Product/Process Change Notice (PCN)

PCN_WE_IndDD_20140425_MiBr.doc

Product Affected: 744878001, 744878002,
744878003, 744878004, 744878005,
744878006, 744878008, 744877001,
744877002, 744877003, 744877004,
744877004A, 744877005, 744877006,
744877008, 744877100, S09100077,
S09100076, S07100085

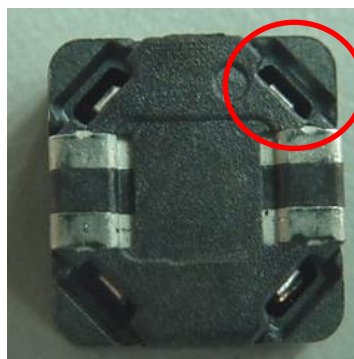
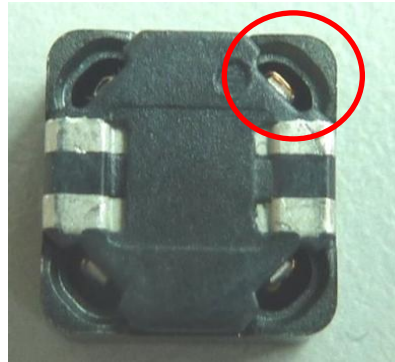
1. For improvement of processability we changed the inner shape of RI core from square to round corner.

1. The inner four corners of the core changed from a square shape to a round shape.

Form, fit and function is not affected.

Reliability: Thermal Shock according to reference MIL-STD-202 Method 107.
